MEMORANDUM

To: **Biologics License Application Submission Tracking Number # 125546/0**

Subject: **Review of Analytical Procedures for Drug Substance of Biologics License Application for Meningococcal Group B Vaccine**

Product: Bexsero - Meningococcal Group B Vaccine

Figure 1. Comparison of Standard Curve Data

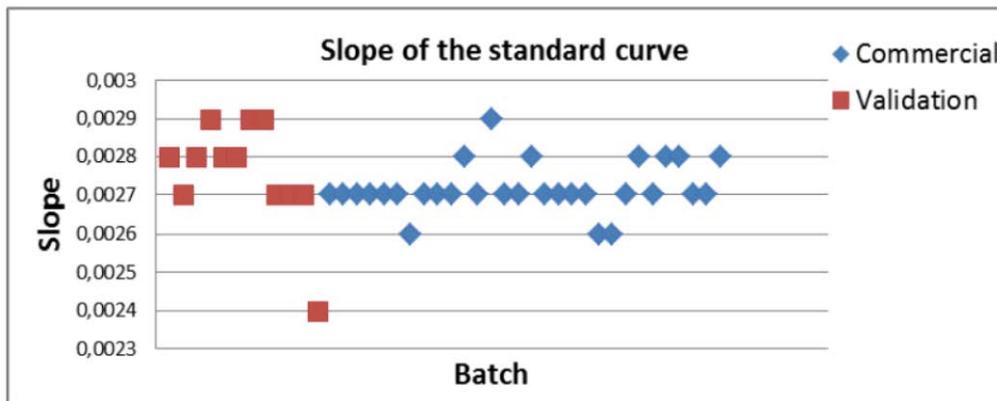
- a) Validated range of linearity should be based on the linearity, accuracy and precision of the samples. The validated range from page 13 of the validation report is between -----(b)(4)----- because -----(b)(4)----- are out of calibrated range. We also noticed that the validated range doesn't cover the specification of (b)(4), which is (b)(4)--. Please provide the validated range 80-120% of the specification range with supporting data.
- b) We found that the slope ratio of DS (b)(4) samples to standard solutions is (b)(4). The acceptable value is usually (b)(4). Your results suggest that using standard solutions as calibration model for (b)(4)- measurement of the DS sample is not appropriate. Please justify your decision of using such calibration model in the assay.

1) The slope ratio of 0.83 corresponds to a slope of 0.0024 for the drug substance bulk sample linearity and a slope of 0.0029 for the standard solution linearity. However it should be noted that other slope values obtained for standard curve linearity during method validation and subsequent routine testing (data shown below for 30 representative tests) are consistently less than 0.0029, as illustrated in Figure 1. As such the slope ratio of drug substance bulk samples to standard solutions using the data from figure 1 are consistently greater than or equal to 0.9.

- 1) The slopes of standard curves were consistently between 0.9-1.1 in their routine testing.
- 2) Recovery of accuracy study in the validated report is 102-105%, which meet the acceptance criterion of ---(b)(4)----.
- 3) There was no interference from either a synthetic matrix or a sample of placebo.
- 4) A qualified and independent positive control is used as system suitability check in the SOP.
